Re: Inspection of Rock Slot
South of West Service Building
Thorold Tunnel, Hwy. 58
District #4, Hamilton

Report Entitled "Thorold Tunnel -
Effect on Tunnel Structure of
Constructing an Extension to the
Upper East Approach Wall, Lock 7"

CONTRACT NO. 12-1826 - Extension of Approach Wall, Lock 7 (1982), Welland Canal, Seaway, Western Region

Re: Agreement No. 4242-9082-124
Report on SLSA Proposed Works
Adjacent to Thorold Tunnel

ACRES	MINISTRY OF TRANSPORTATION AND COMMUNICATIONS		
	THOROLD TUNNEL STUDIES		
EXISTING CONDITIONS AT TUNNEL STATION 61+03± (FT) LOOKING EAST			
ACRES	DATE SEPT, 1982	SCALE AS SHOWN	
	DEPARTMENT	DRAWING NO.	REV.
PROJECT	PLATE 1	SHEET OF

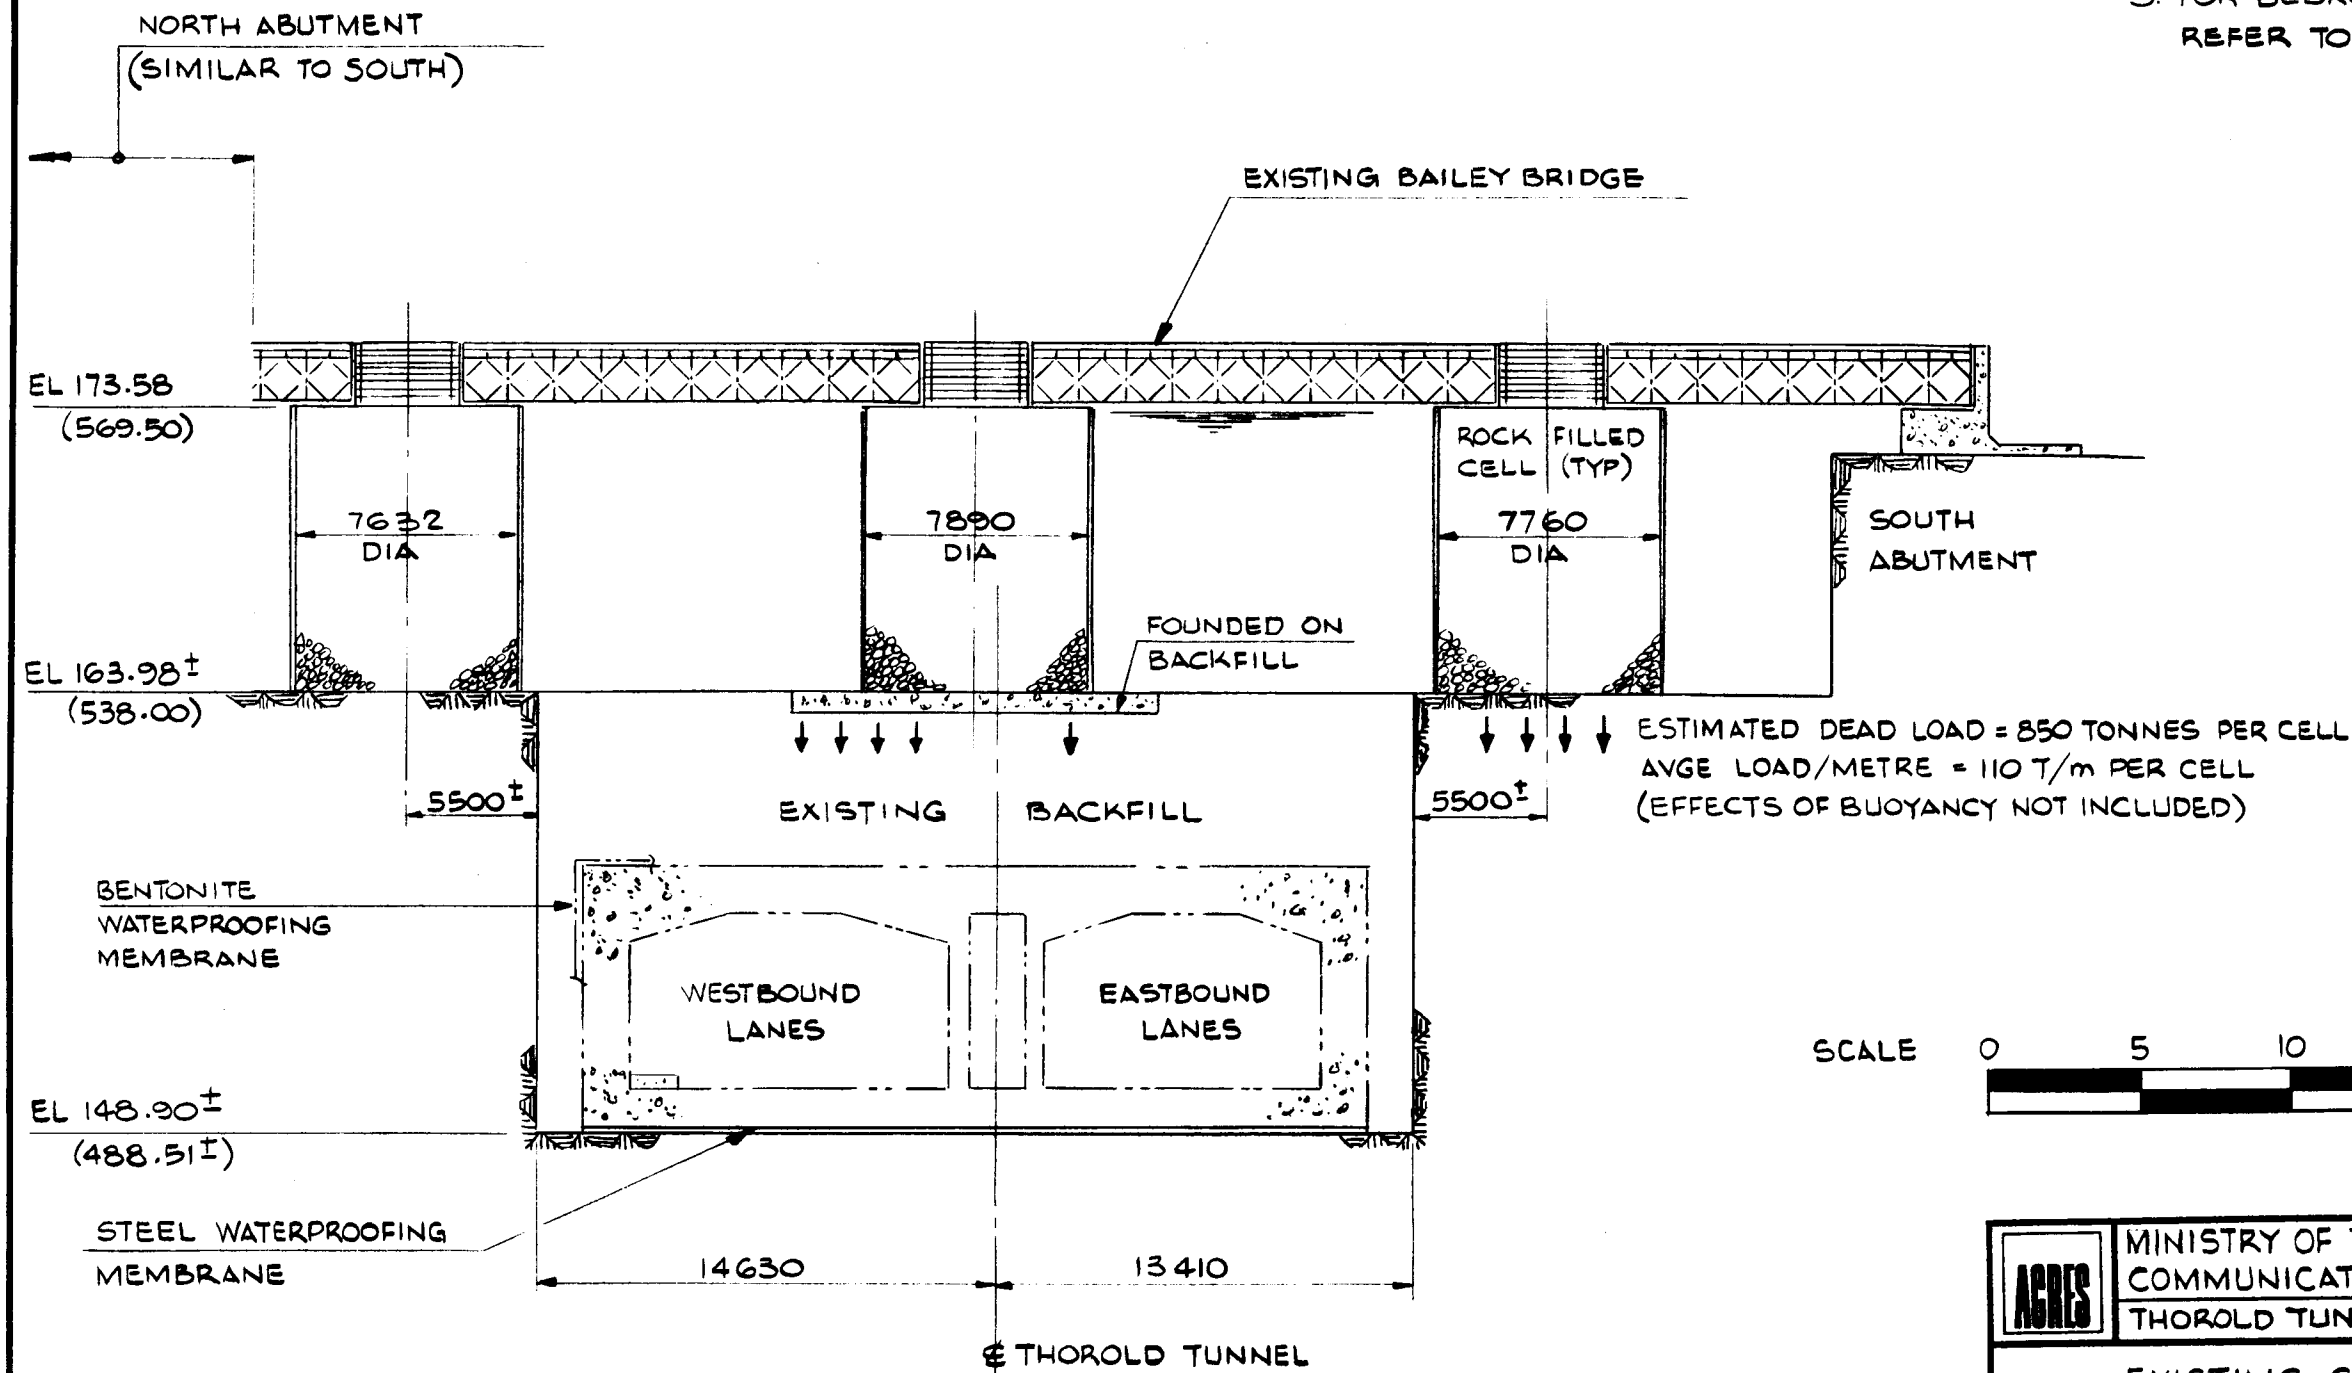
Calculations of gravity loads from the existing Bailey Bridge and proposed new approach wall indicate that although the total load per pier for the new structure will be higher than that from the existing Bailey Bridge, the average gravity load per unit width of pier is about the same for each case, as shown on Plates 1 and 2. The vertical prestressing of the anchor rods adds a load of 691 t per pier for the new structure. This will make the average stress under the new pier approximately 1.5 times higher than the existing. The effect of this additional vertical loading on rock squeeze and bench stability is thought to be minor.

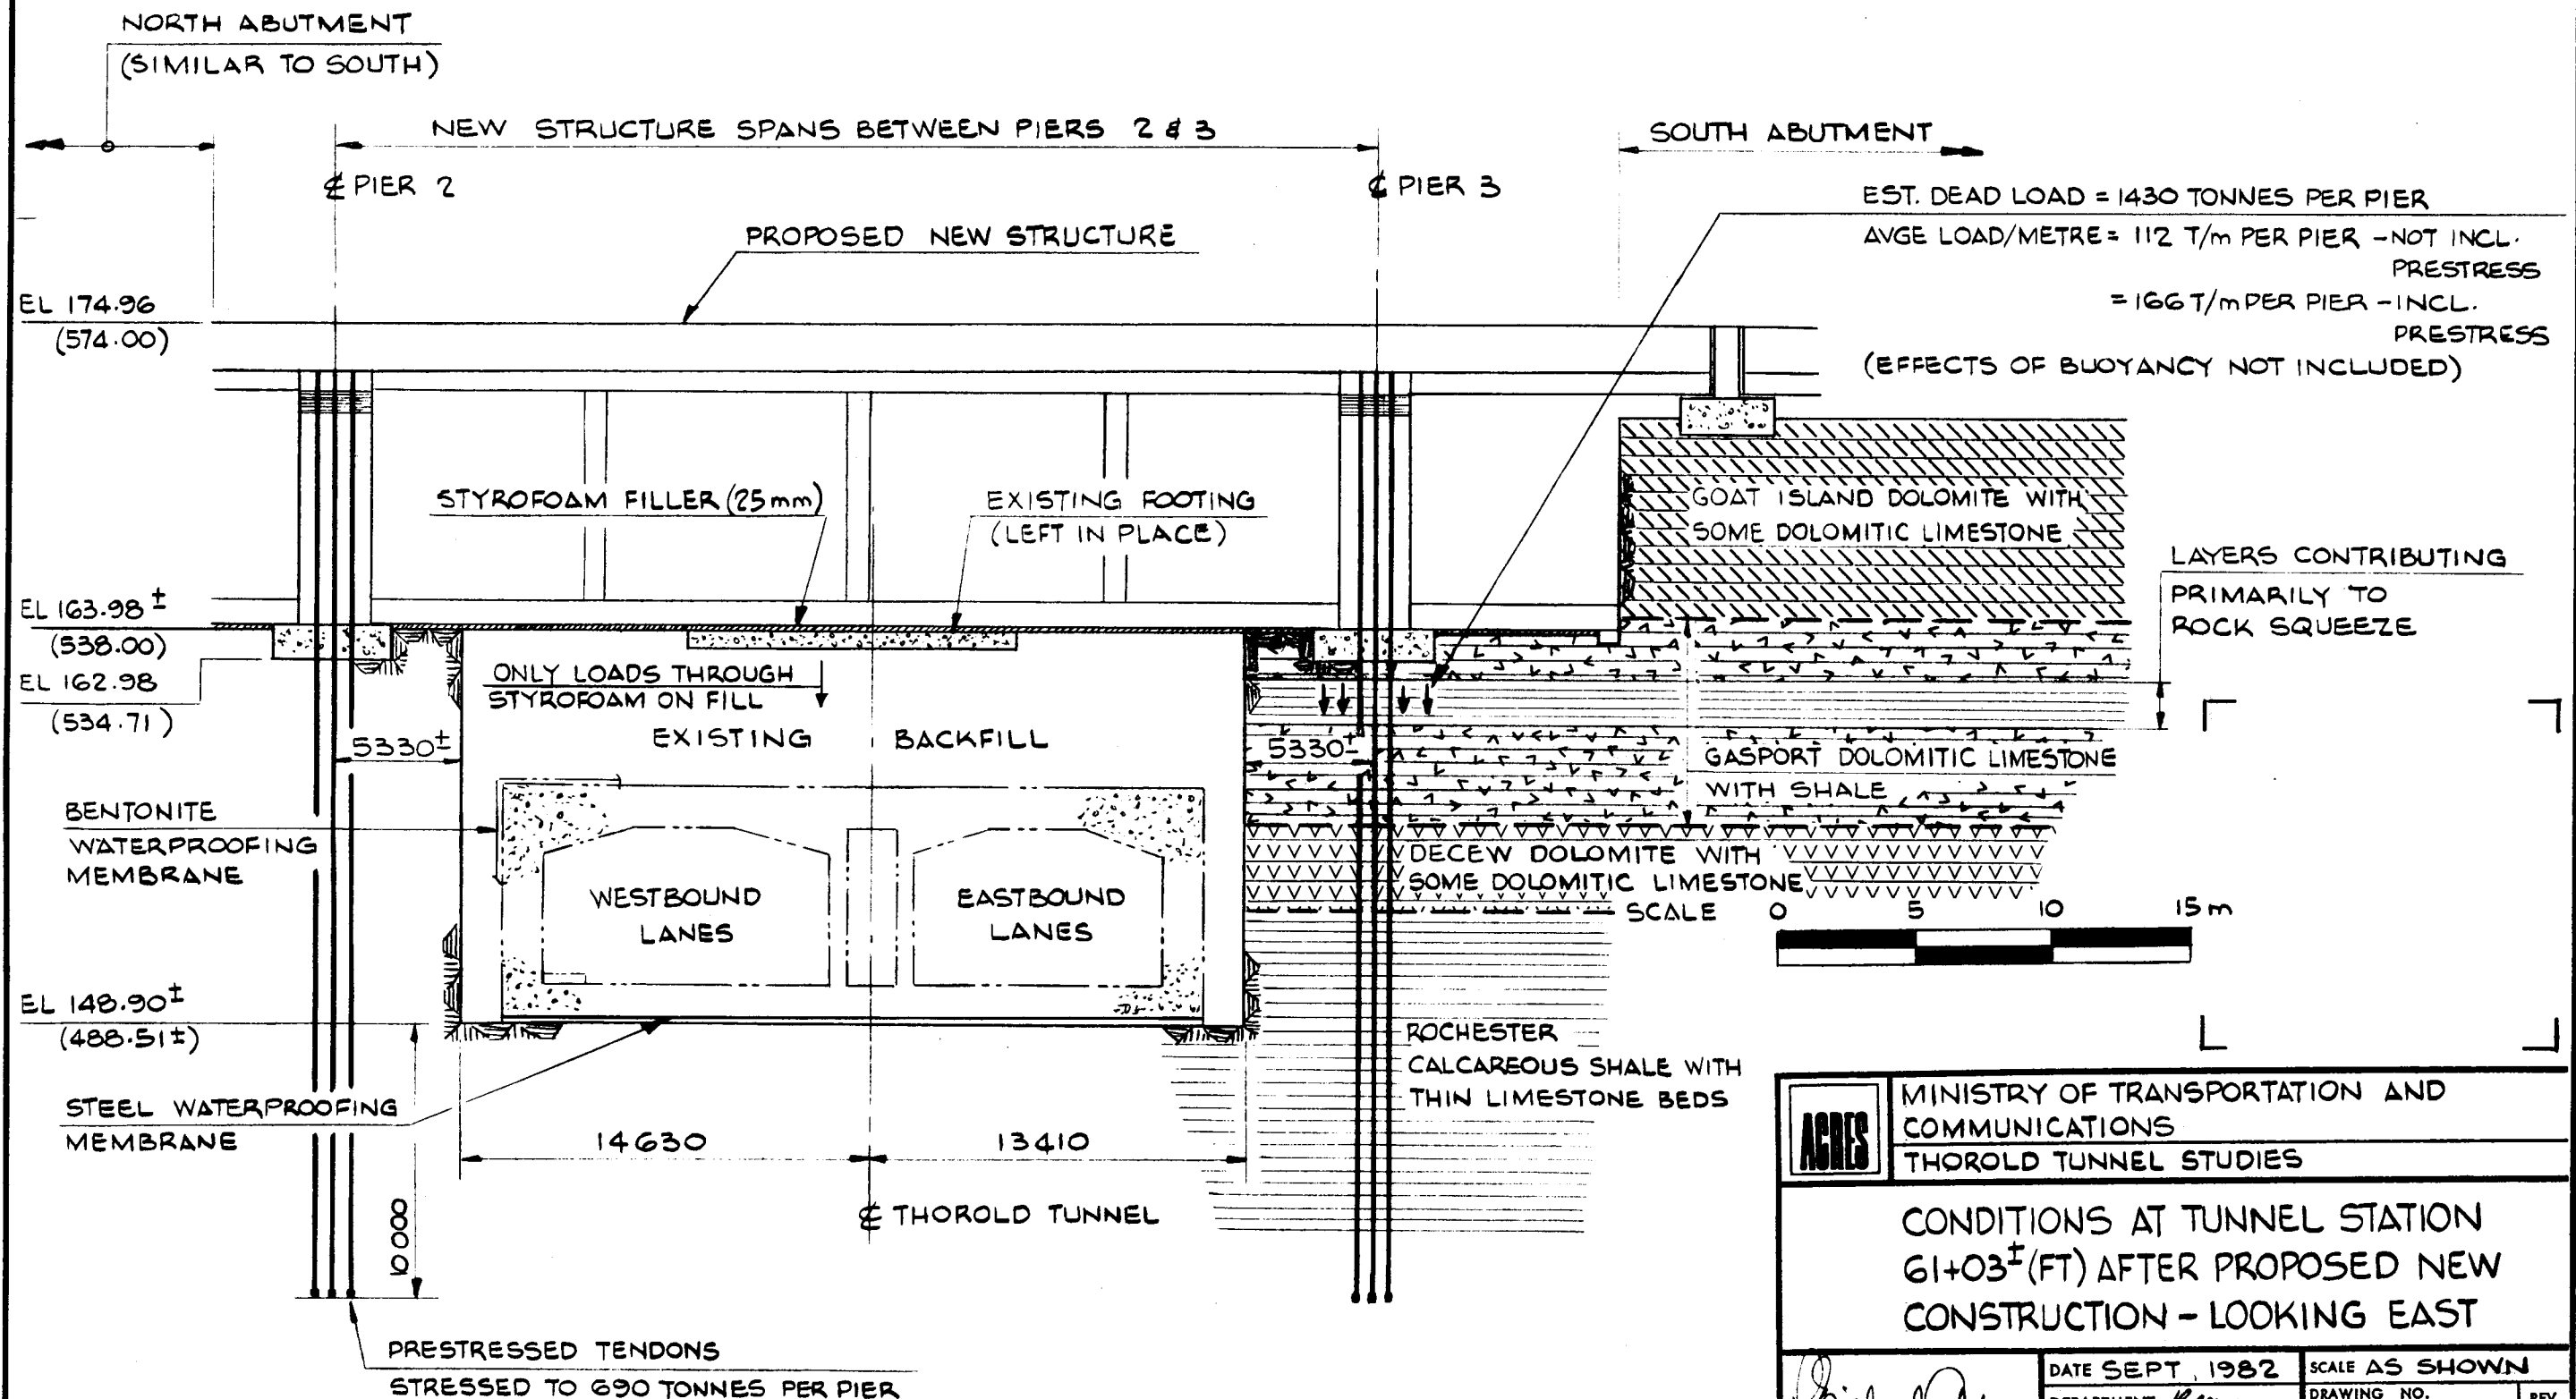
- (a) It is recommended that the SLSA be requested to advise if horizontal loads of significant magnitude, i.e., greater than 1,000 kN or 100 t, are expected to be transmitted to the base of the wall footings. If such is the case, it is conceivable that the ledge of rock might be in danger of failing by sliding depending on the magnitude of the load.
